Department of Energy
Washington, D.C. 20545
Docket No. 50-537
HQ:S:82:149

MEETING SUMMARY FOR THE SHUTDOWN HEAT REMOVAL MEETING, DECEMBER 16, 1982

BRIEFING ON
CRBRP SHUTDOWN HEAT REMOVAL CONCERNS

Shutdown Heat Removal Meeting
December 16, 1982
Agreements and Commitments

UPDATED DHRS SINGLE FAILURE ANALYSIS

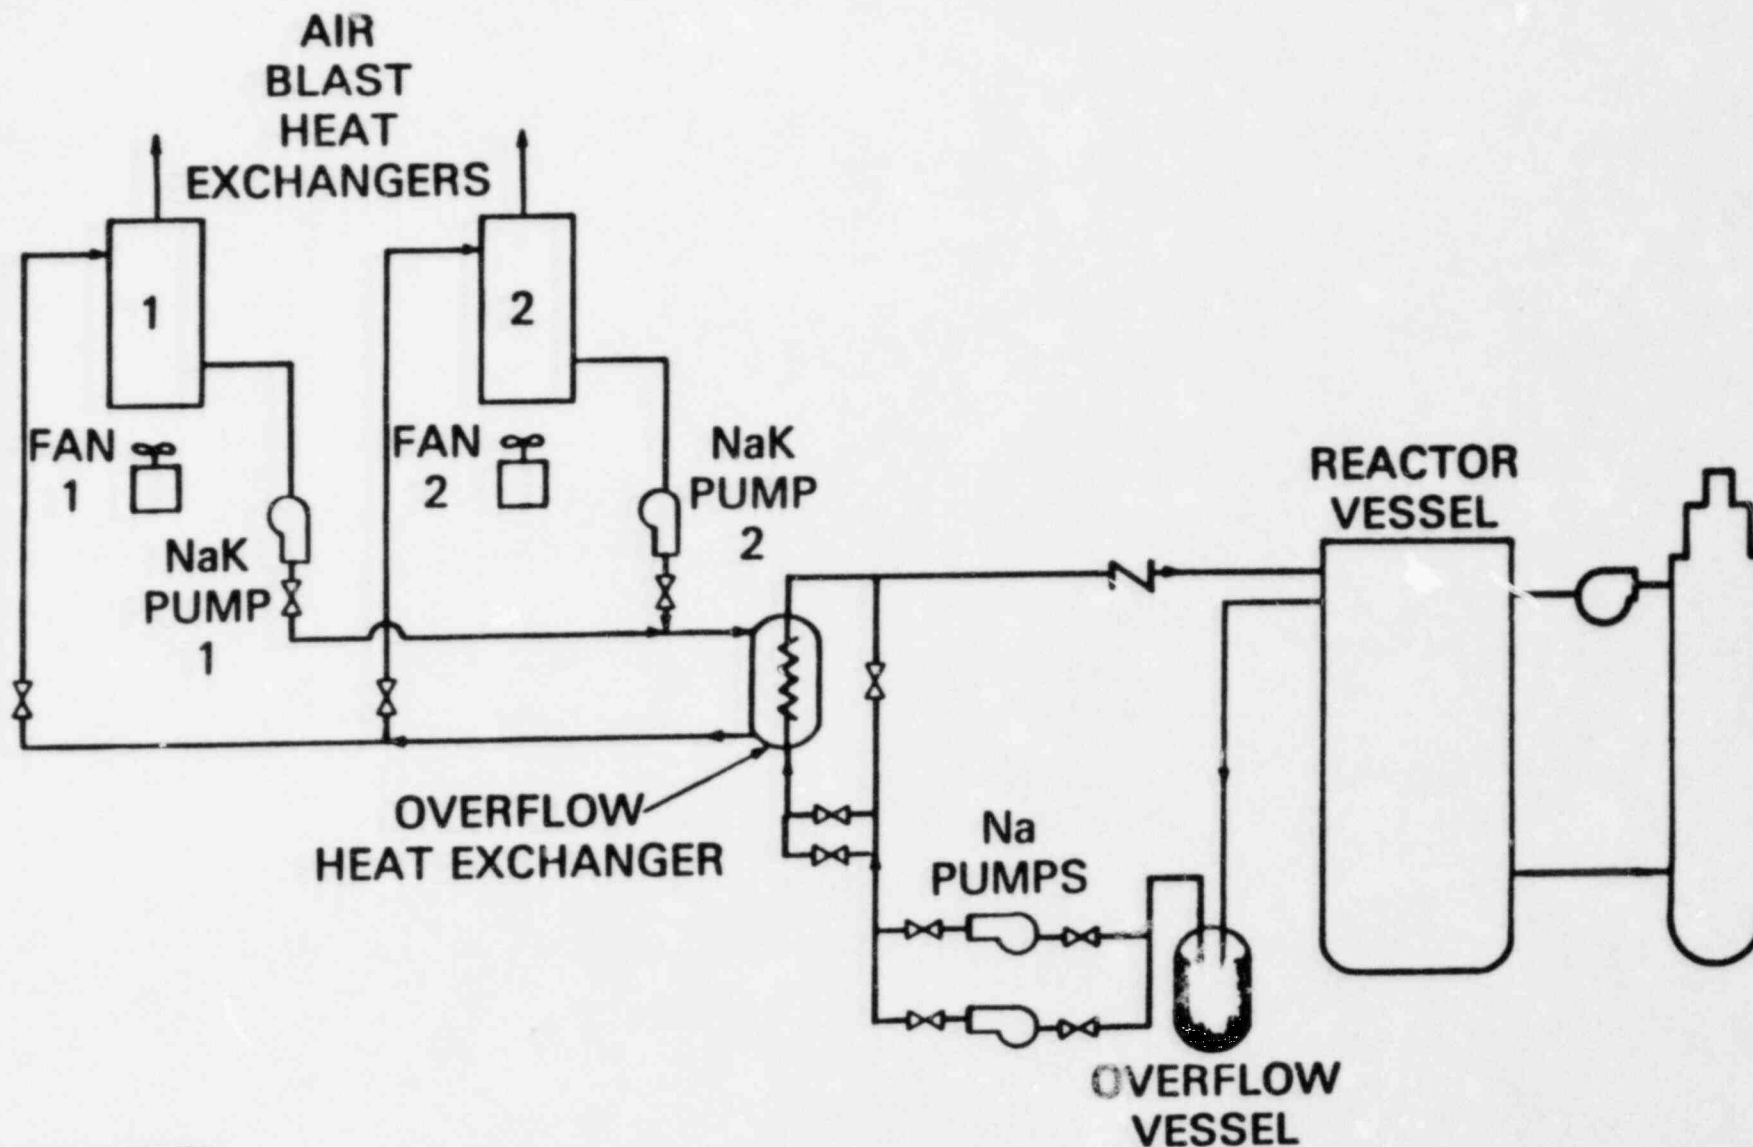
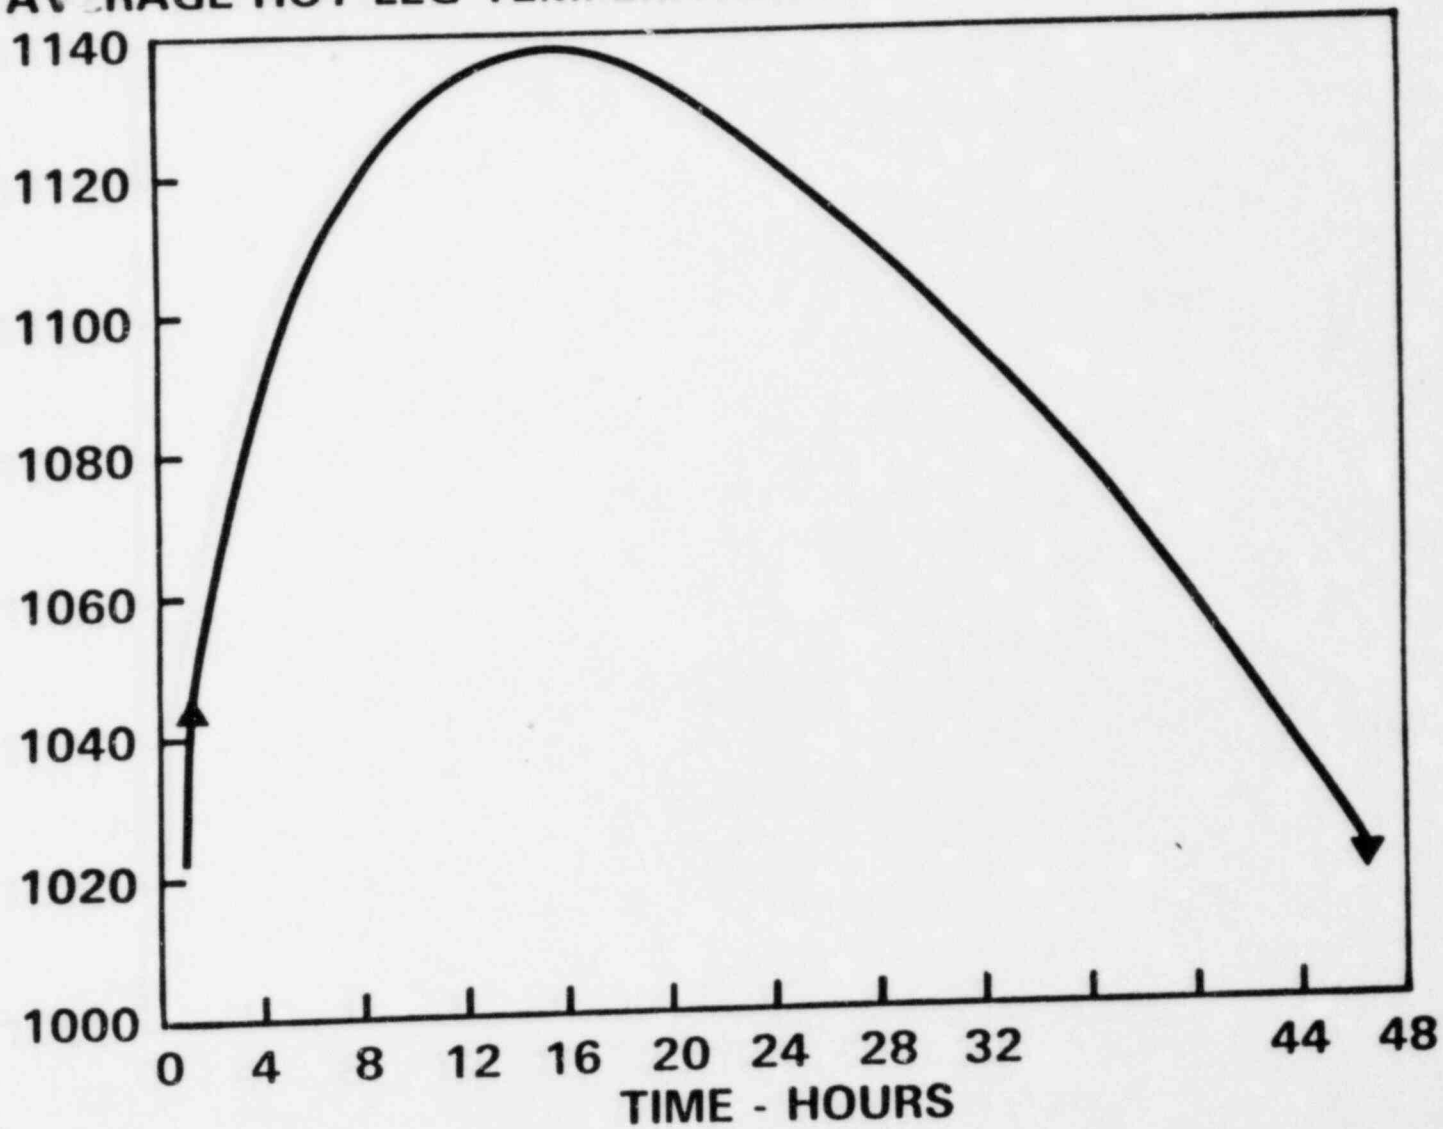
The specific changes to incorporate single failure capability, the results of latest single failure analysis, and the details of the base case F-2 analysis were discussed. (see attached)

The peak temperatures for the single failure assessment slightly exceed (by 17°F) the structural peak temperature analyzed for the F-2 transient. This is judged acceptable based on a scoping analysis since the capability of the primary boundary to maintain structural integrity, based on creep rupture considerations, at temperatures of approximately 1200°F is approximately 100 hours.

Action: The updated (performance) design case and the single failure evaluation case will be placed in the PSAR in addition to the description currently in the PSAR concerning the structural design case.

This item is resolved for the SER.

Long Term Natural Circulation Event (Two Hour Station Blackout)

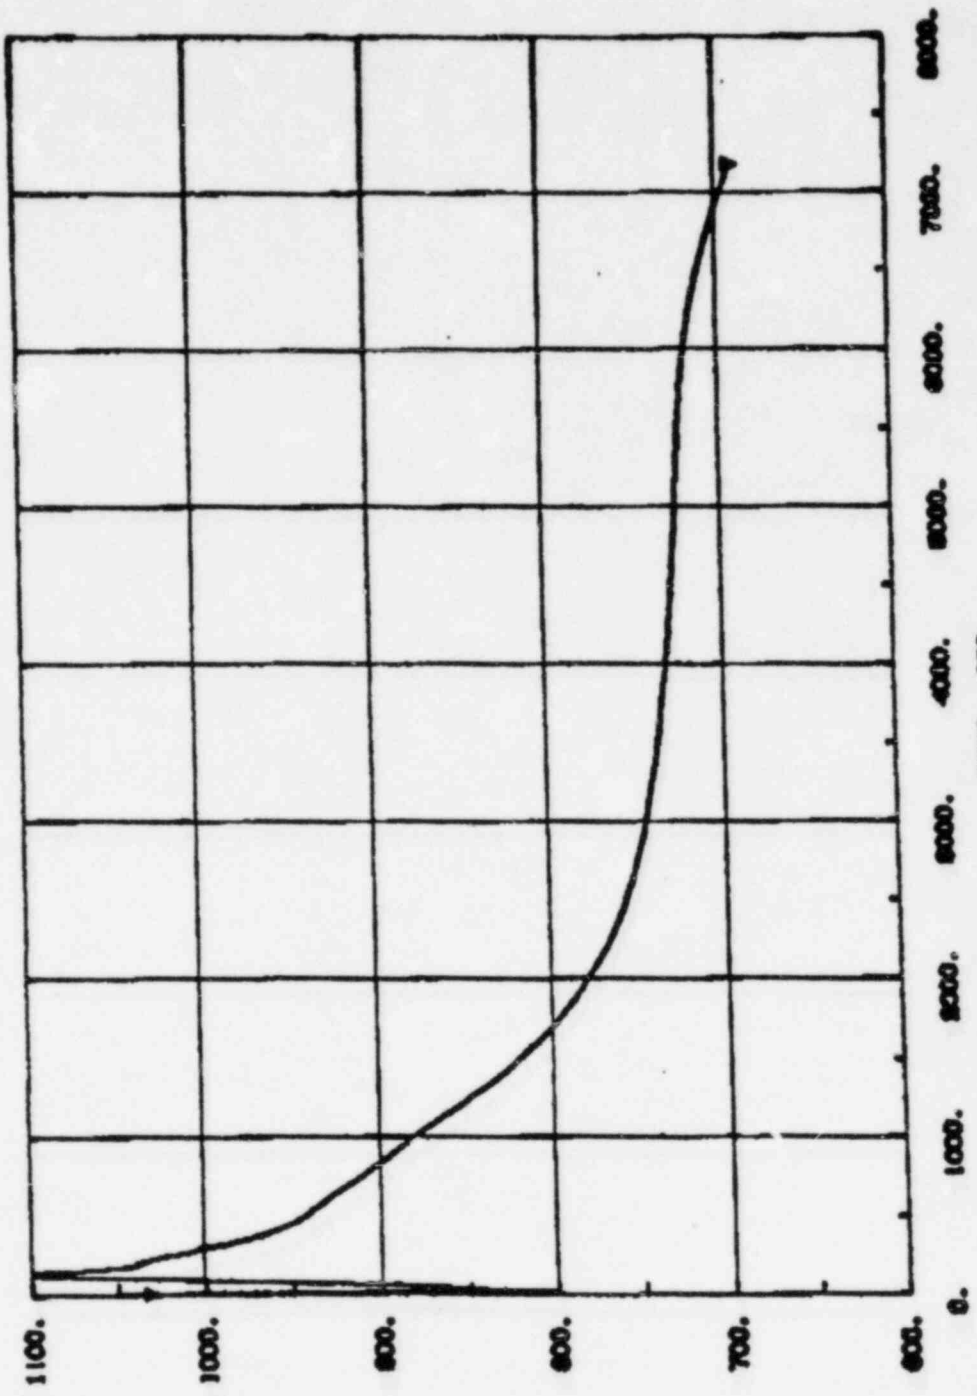
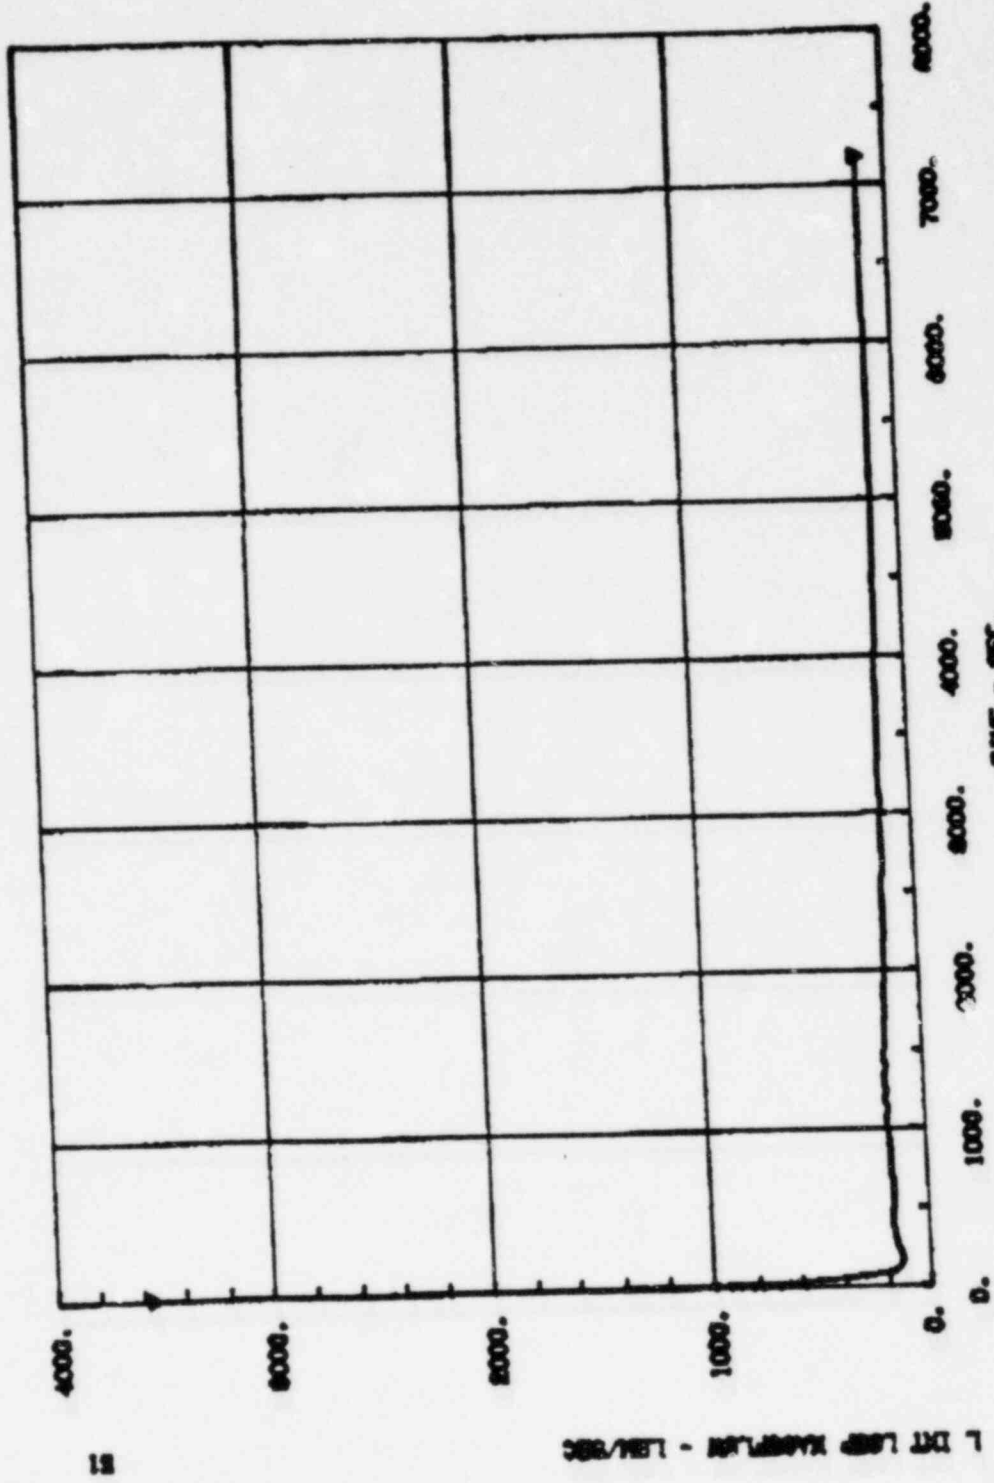
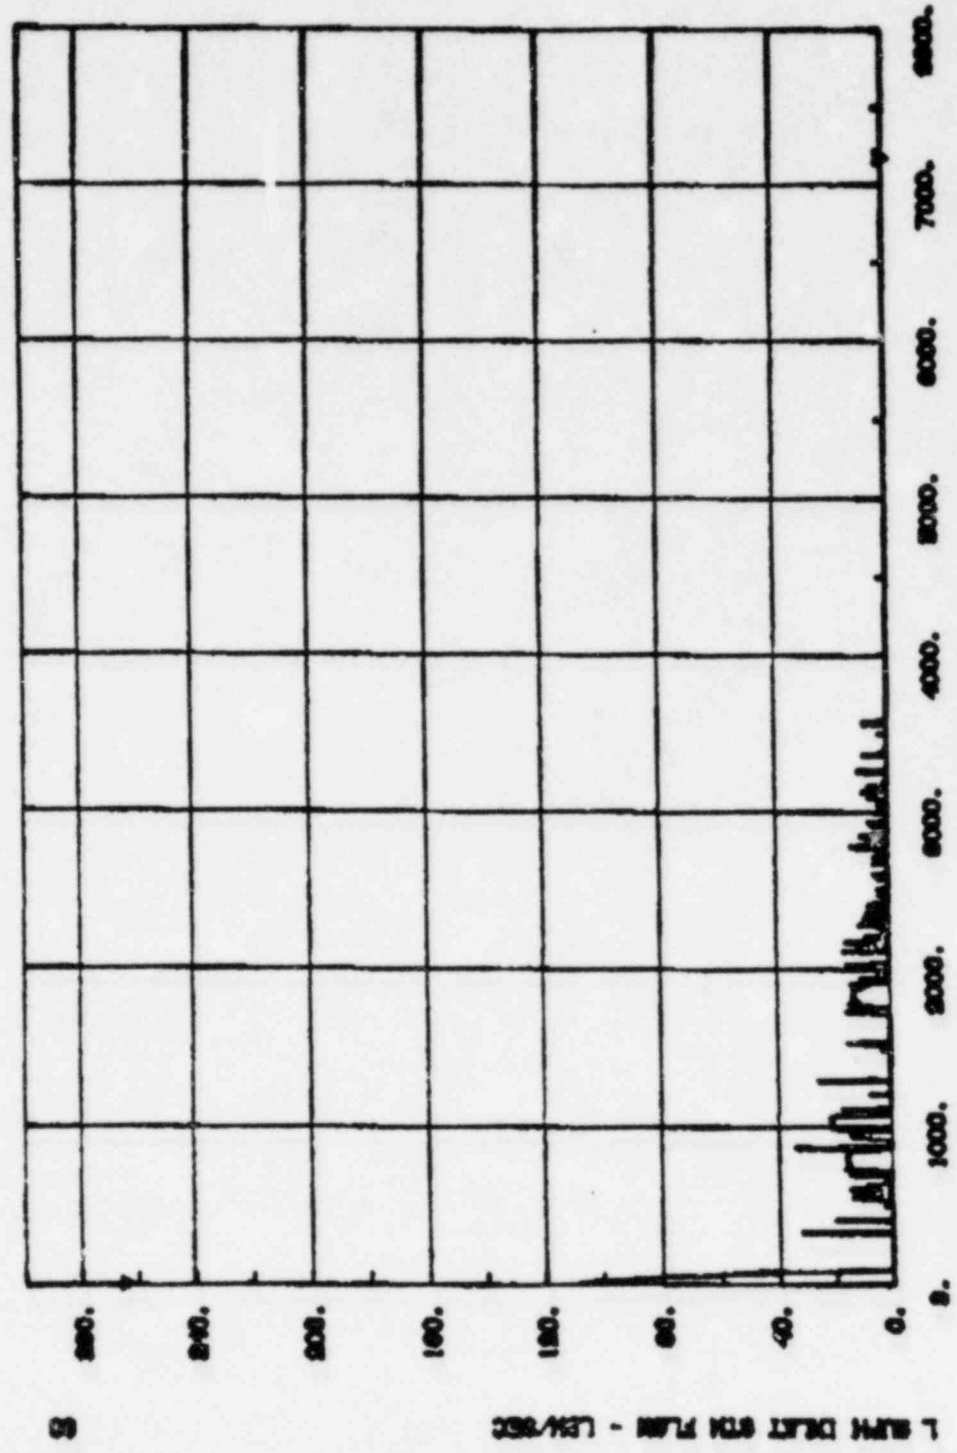
The results of long term natural circulation analysis were presented (see attached).

The staff requested natural circulation analyses extending beyond the 600 second transient time cases previously submitted by the applicant. The objective of the extended analyses was to demonstrate continuing stable natural sodium circulation and acceptable transition in heat sink configuration from steam venting to PACC's only operation.

This item is considered resolved for the SER.
